N1- CB19 3 WIRES

The release of the CB 19 occurred which replaces the CB 9 board. The features are similar to other Menu driven control boards.

○ 3 Wires wiring diagram:

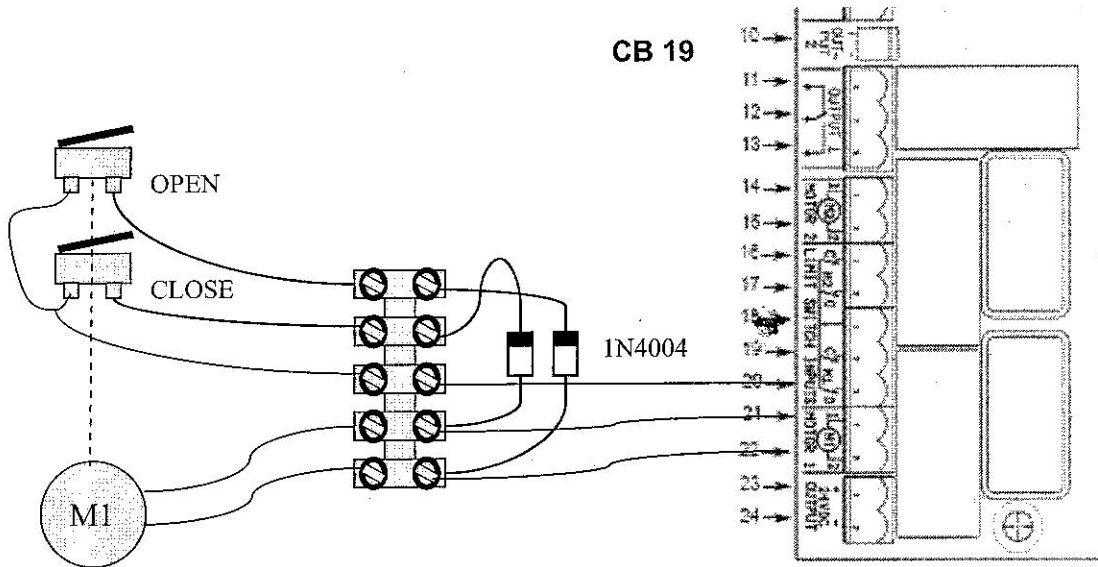
Some difficulties have been experienced with 3 wire systems. Boards require modification before these can be fitted. An update on firmware and hardware will be developed that will allow all CB19 to operate regardless on motor system. For now please order CB19 and ask for this modification to suit 3 wire systems.

Wiring details when using a terminal block for a 3 wire system. Duplicate for M2 wiring, see page 6 of the CB19 manual.
